Permit Application Review

Permit No. 2020-96
Received complete: September 8, 2020

Project: Trail Improvements

Location: West Bush Lake Road from West 86th Street Circle to Park Knoll Circle:
Bloomington

TRAIL RECONSTRUCT
WEST BUSH LAKE ROAD:
FROM STA 7+50
TO STA 15+00

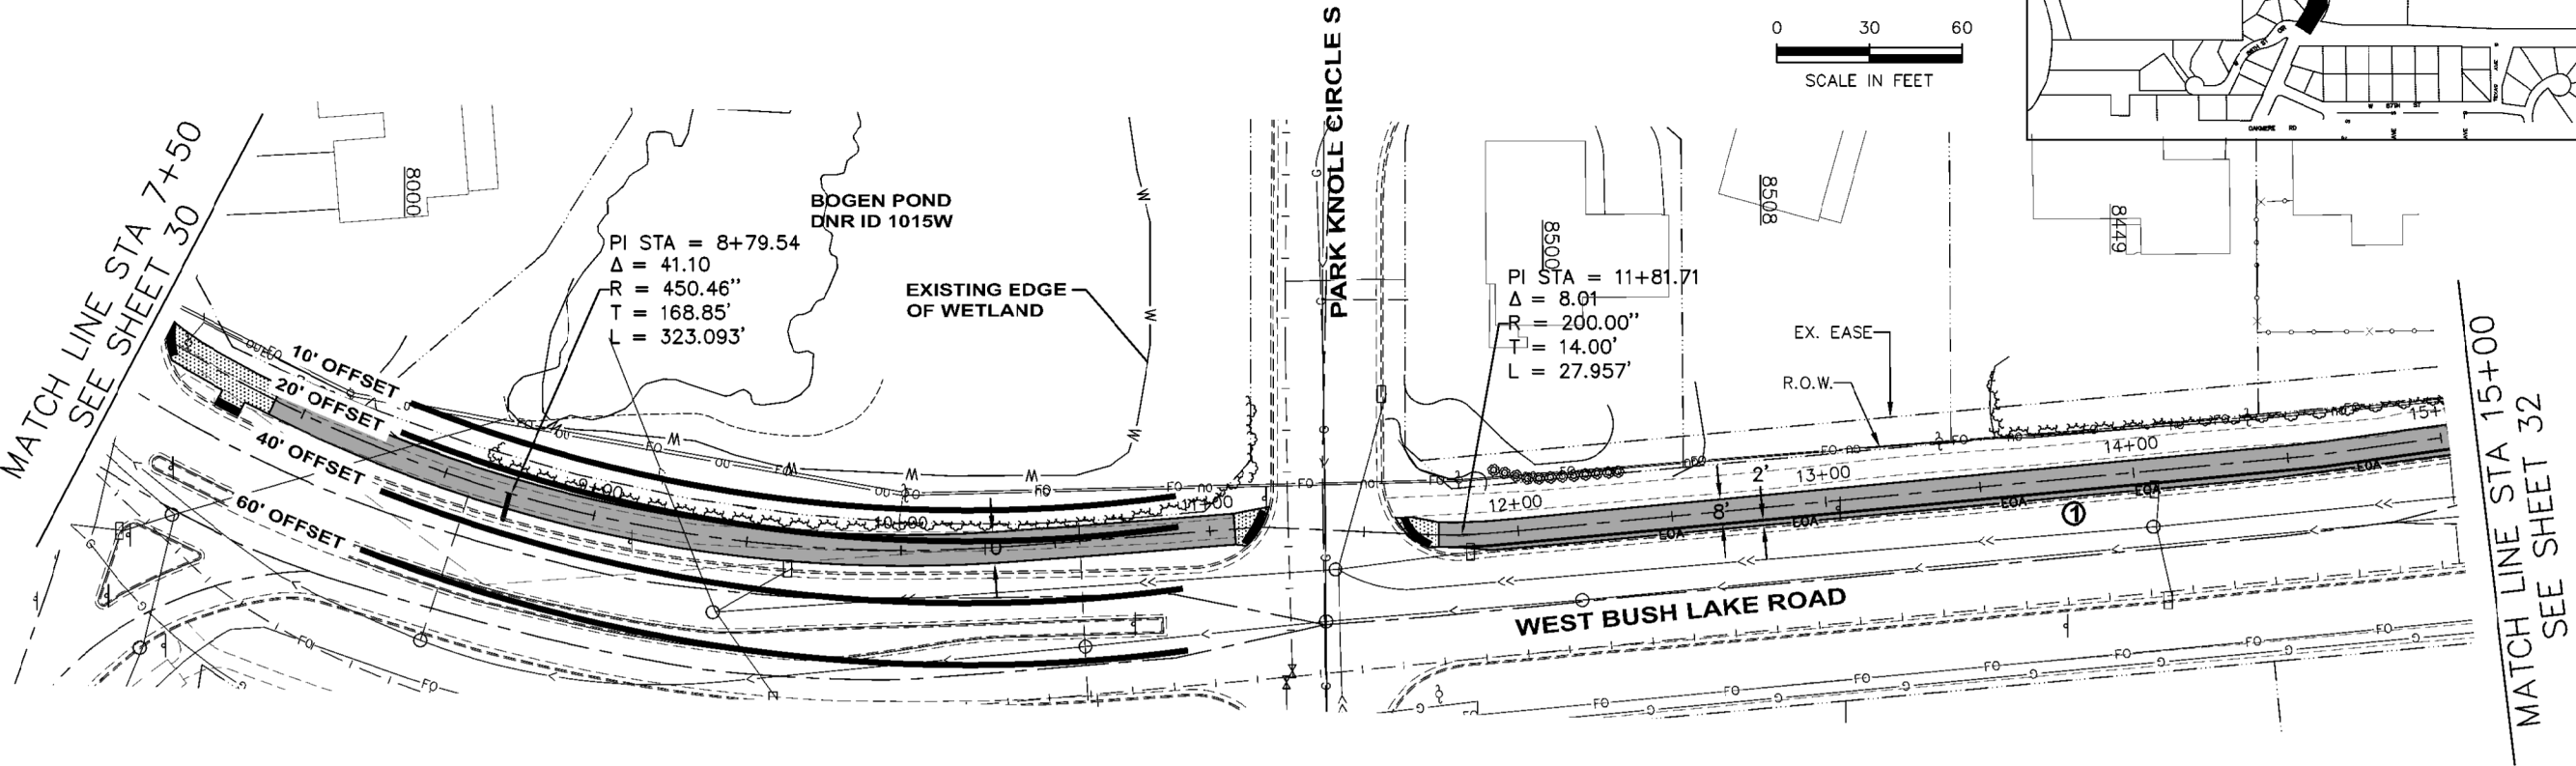
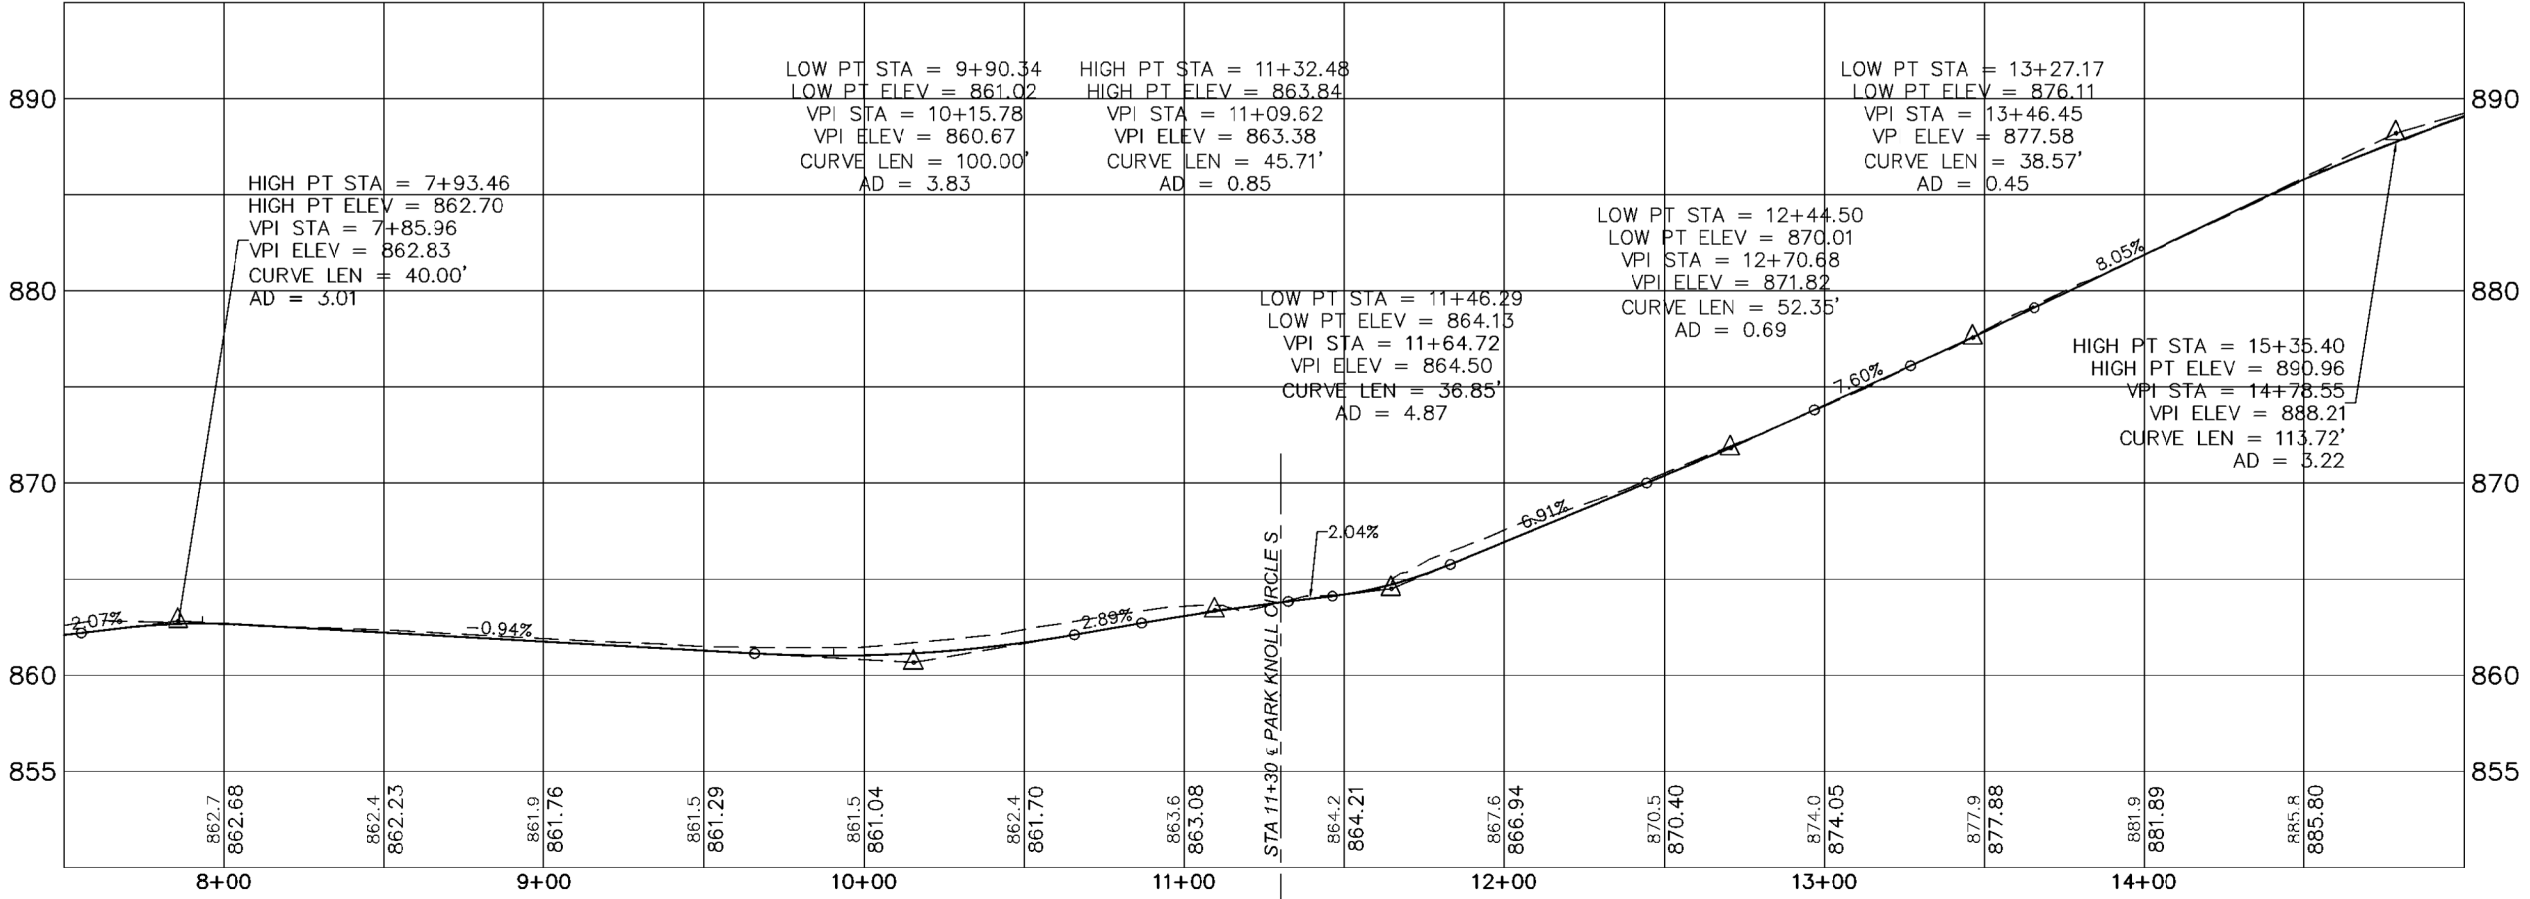
The City's Plan classifies the wetland as high value requiring a 30-foot minimum and 60-foot average buffer width, Rule 3.4.1a. We agree with the wetland classification. Both the existing and proposed trail location are shown to be within approximately 20 feet of the wetland boundary for approximately 350 feet, the total length of the trail riparian to the wetland. The city has requested approval of a variance from Rule 3.4.1a for the trail and is further discussed in the Rule 10 paragraphs. As previously stated, the trail is for non-motorized use. Buffer markers, in accordance with Rule 3.4.5, are required to be installed.

A variance request for compliance with Rule 3.4.1a (attached) has been prepared by the City of Bloomington to address Rules 10.1-10.4. The variance request is for compliance for both the 30-foot minimum and 60-foot average buffer required from the boundary of wetland 1015W. The location of both the existing and proposed trail is dictated by West Bush Lake Road. The trail alignment that is within 30 feet of the wetland boundary is approximately 350 feet in length, the total length of the trail riparian to wetland 1005 W. As previously stated, both the 30-foot minimum and 60-foot average distance extend onto West Bush Lake Road. The functionality and integrity of the existing buffer will not be diminished by the project. The only alteration/disturbance proposed being the reconstruction of a 10-foot wide trail and the removal of invasive species (buckthorn). Stormwater

STORM WATER POLLUTION
PREVENTION PLAN (SWPPP)
WEST BUSH LAKE ROAD

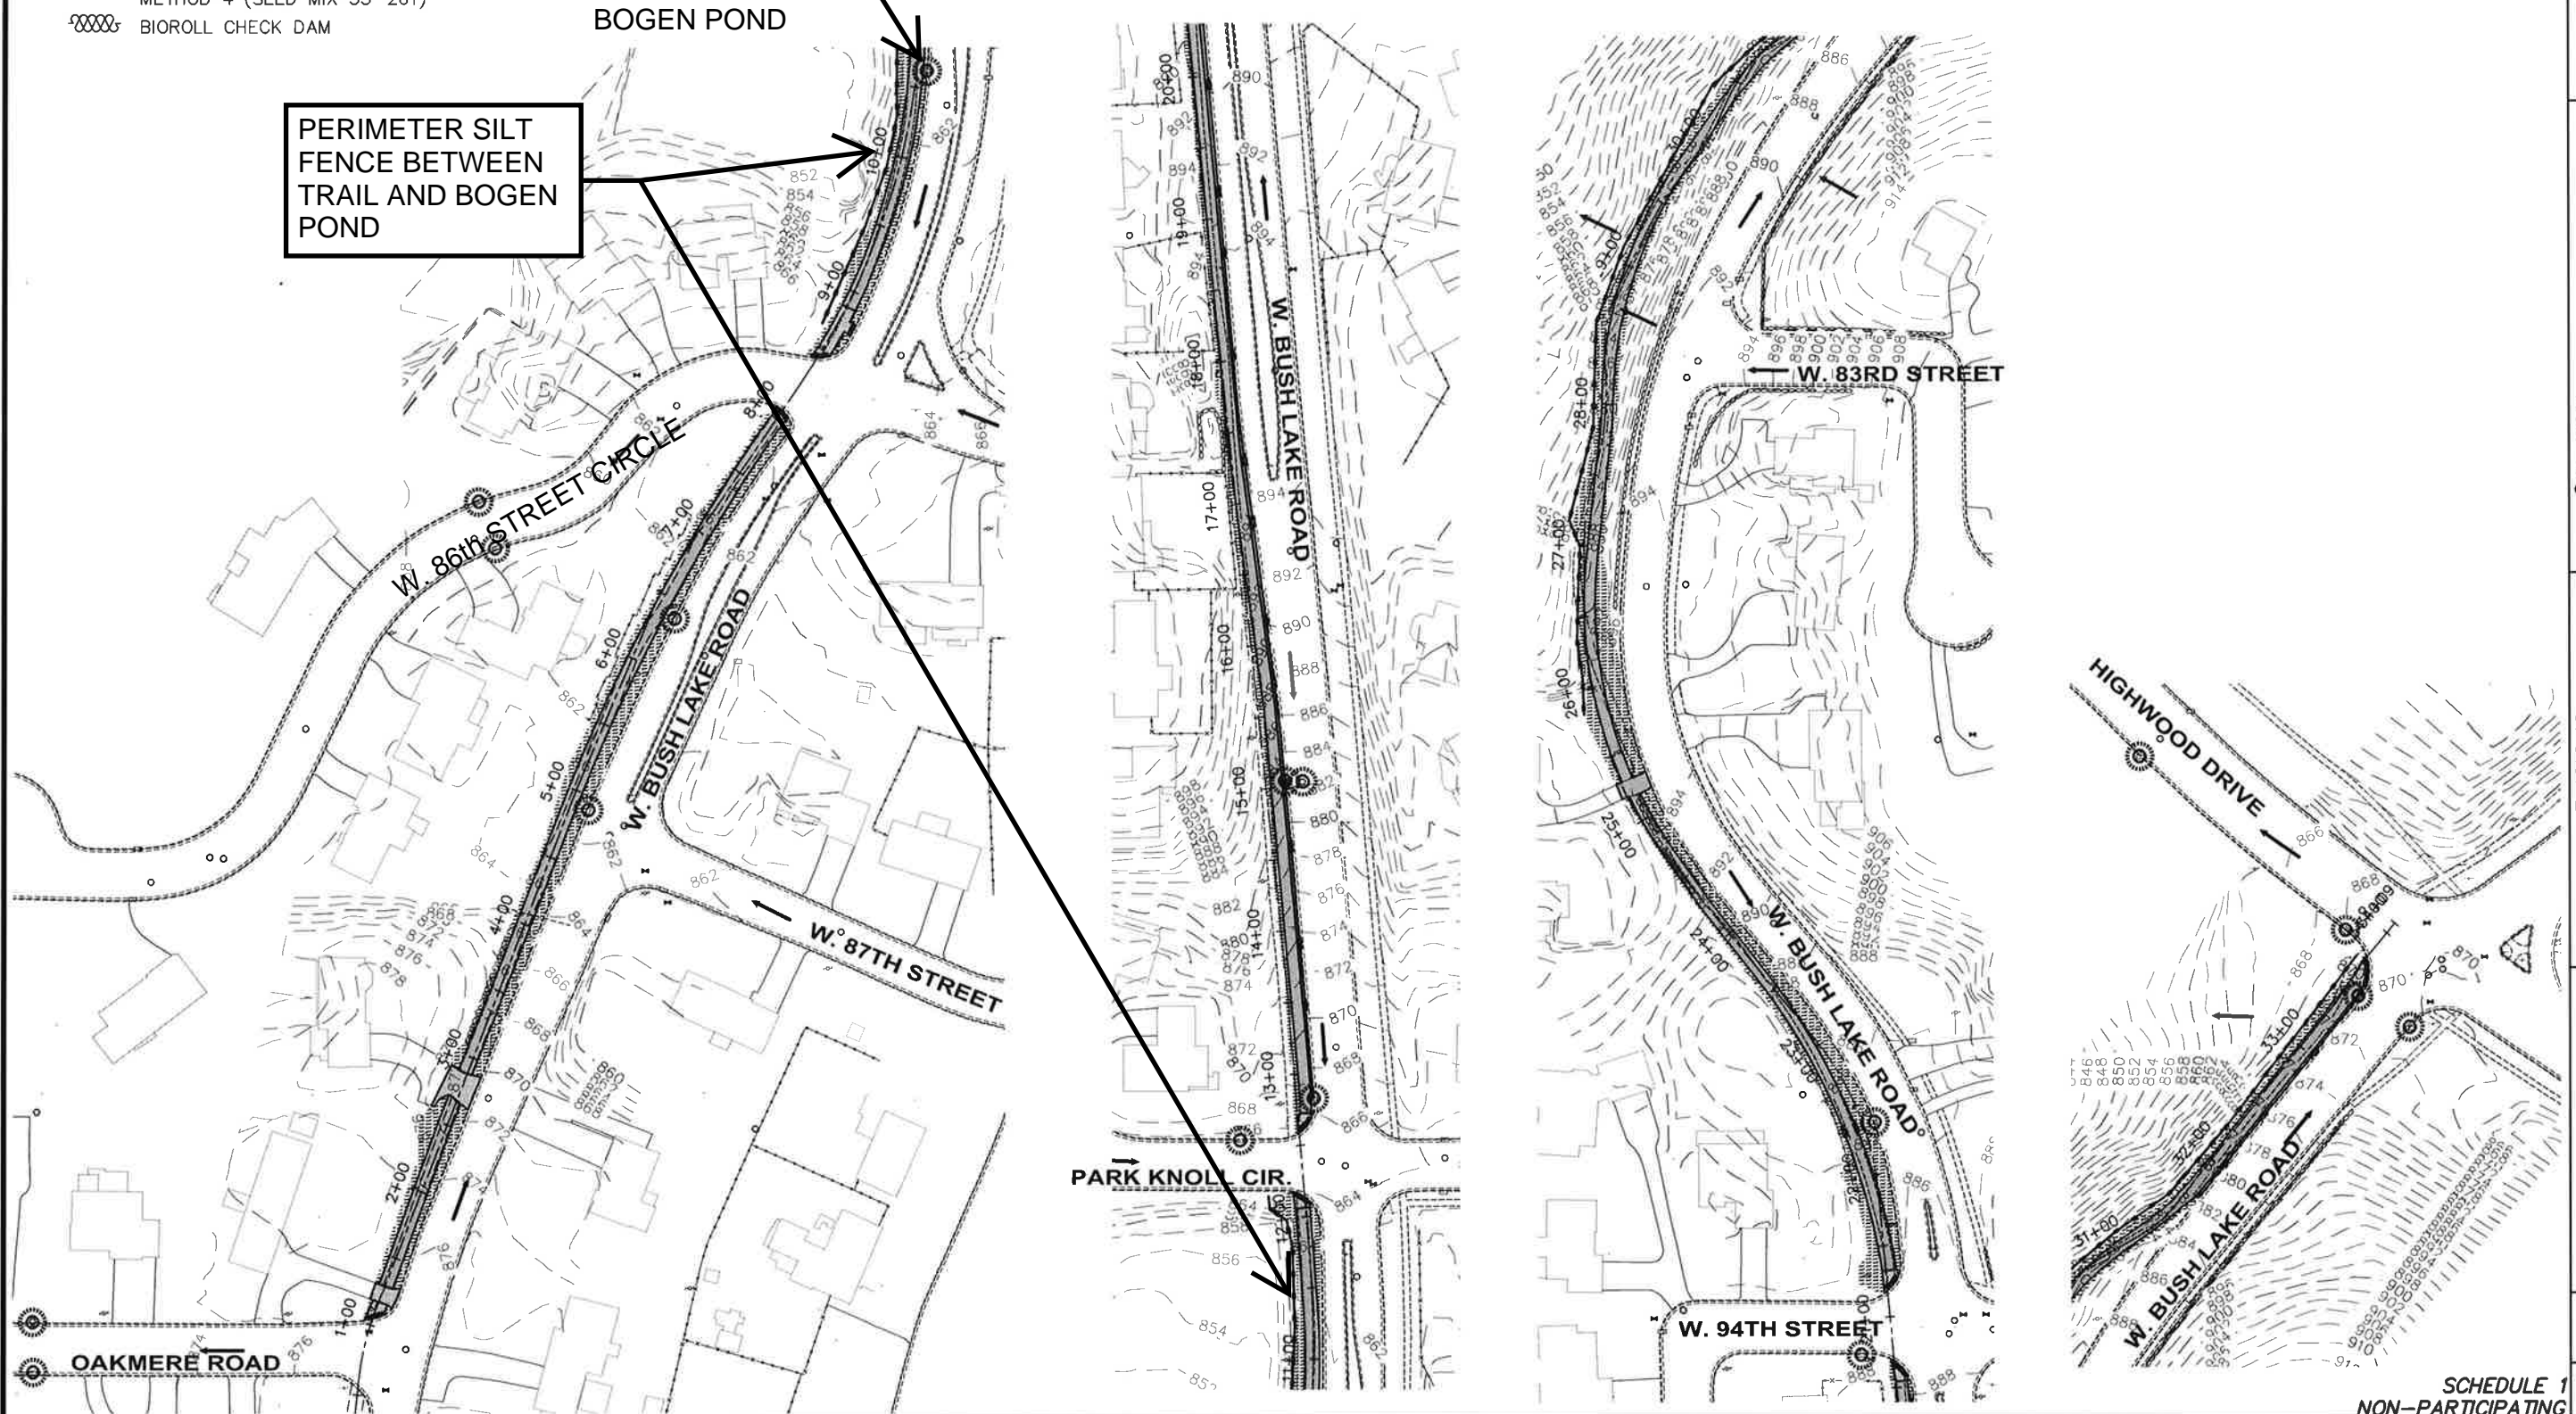
Erosion and sediment control plans for the proposed work were submitted. Silt fence, storm drain inlet protection, hydromulch application and erosion control blanketing will be utilized for erosion prevention and sediment control measures. Sod and native seed mixtures will be implemented for final stabilization measures. Restoration, as proposed, complies with the requirements of Rule 3.4.6.

PERIMETER SILT FENCE BETWEEN TRAIL AND BOGEN POND
